**ADDENDUM NO: 1****IMPROVEMENTS to PAVILION LAKE PIERS,  
DOCKS and GANGWAYS****DATE: 3/26/2020****BID NO: 01-2020****BID OPENING DATE: April 6<sup>th</sup>, 2020 @ 4:00PM.****NUMBER OF PAGES: 24**

### Description: RFI Questions and Answers

**SUBSURFACE EXPLORATION AND  
GEOTECHNICAL ENGINEERING EVALUATION  
WALL/BOARDWALK & FLOATING DOCK PROJECT  
TORRY ISLAND, BELLE GLADE, FLORIDA**

### Pin Pile Installation

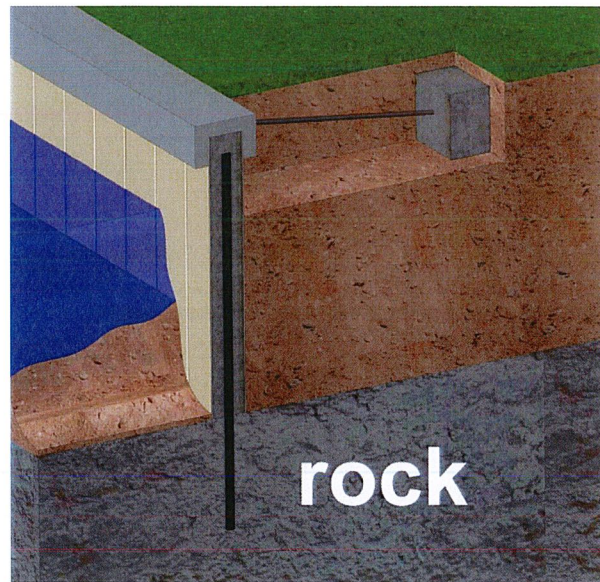
15. What is the anticipated procedure if sheet pilings refuse in limestone layer when installed via conventional vibratory methods?

16. Boring #3 indicates limestone with blow counts of 50/6 will be encountered some 8 to 10 feet above sheet pile tips, as does Boring #2 with blows of 24/6 some 3 to 4 feet above tip. The Truline 800 series is a very light and thin vinyl section that will not penetrate these layers without continuously pre-drilling the setting line. Is it the Engineers intent to allow refused sheet cut-off or should Contractor plan to pre-drill setting line? Please understand there is a significant cost difference between these methods.

**MUE Response: Installation of pin piles inside the Truline sheet pile section is recommended as per Truline's installation recommendations for this condition (see below)**

**MUE Response: Installation of a pin pile inside the truline sheet pile section as per truline's installation recommendations indicated below.**

When conditions PREVENT the sheet to be installed to the required depth for a stable wall.

- Truline is first driven to refusal.
- A pin pile is then driven into the rock, extending below the toe of the sheet and up into the hollow of the Truline form.

BORING LOCATION PLAN  
 Figure No. 2

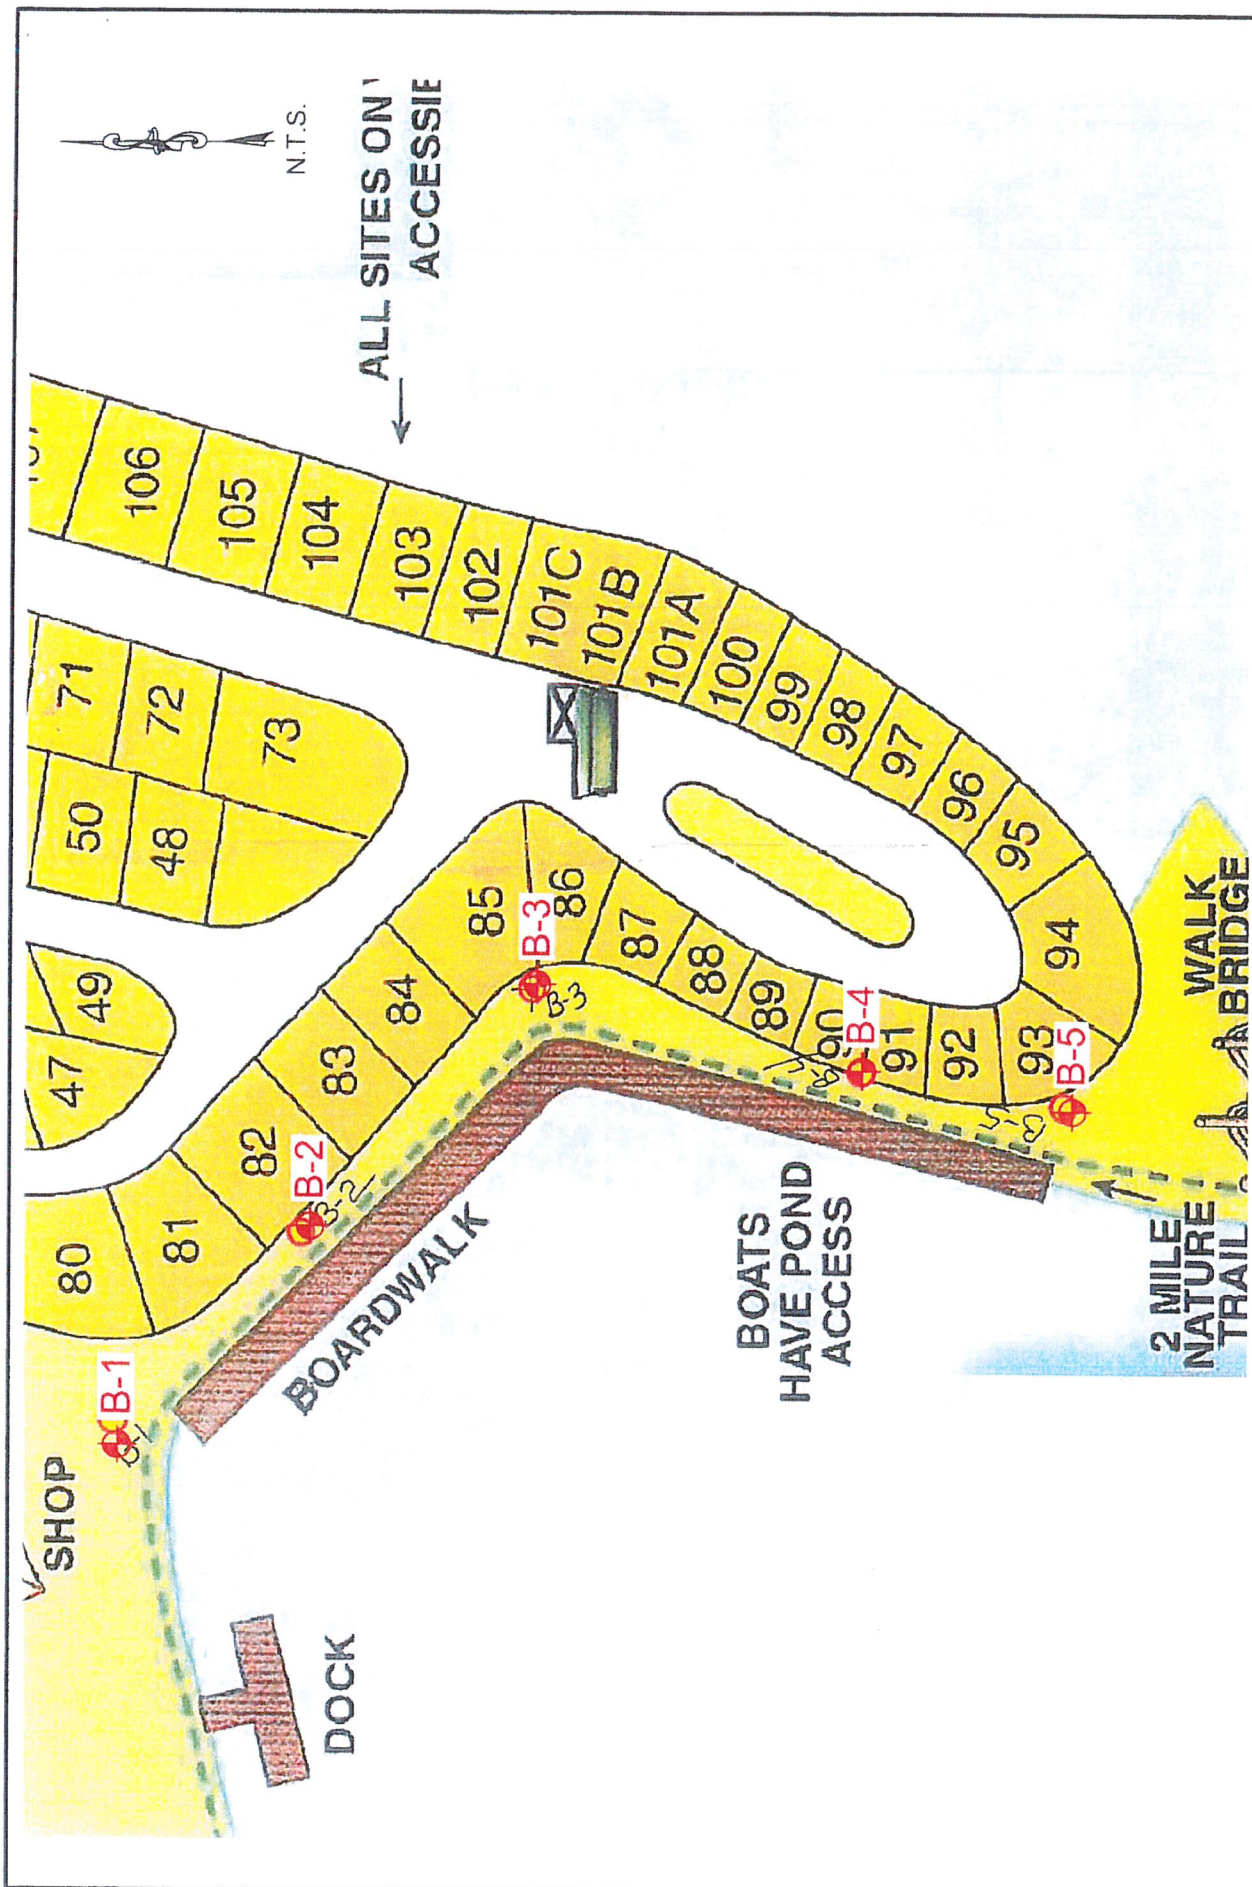
13. Is there a plan view map showing locations of borings?

**Post geotechnical report online? Answer: The geotechnical report has been posted online. The requested map appears on, or about page 7. A copy will be attached to this Addendum 1.**
